# UNITED STATES PATENT AND TRADEMARK OFFICE

APPLICATION NO.	FILING DATE	FIRST NAMED INVENTOR	ATTORNEY DOCKET NO.	CONFIRMATION NO.
10/023,430	12/14/2001	Carlos J.R.P. Augusto	VAN-109	7234
20028	7590	03/23/2004	EXAMINER	
LAW OFFICE OF BARRY R LIPSITZ 755 MAIN STREET MONROE, CT 06468			LEUNG, QUYEN PHAN	
			ART UNIT	PAPER NUMBER
			2828

**Office Action Summary**

FIG. 23

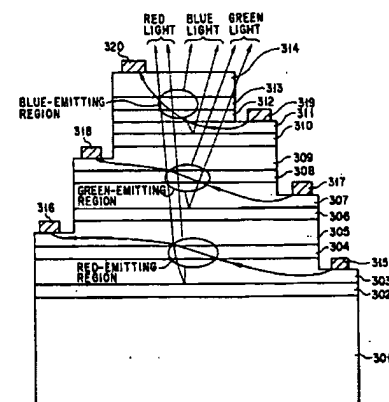
6. Claims 1-21 are rejected under 35 U.S.C. 102(b) as being anticipated by Ishikawa et al (5,696,389). Ishikawa et al discloses the claimed invention. Note figure 23 which illustrates an optoelectronic device comprising a substrate (301), a number of different active layers (304,308,313), a number of different barrier layers (303,305, 307, 309, 312,314), and contact means (315,316,318,320).
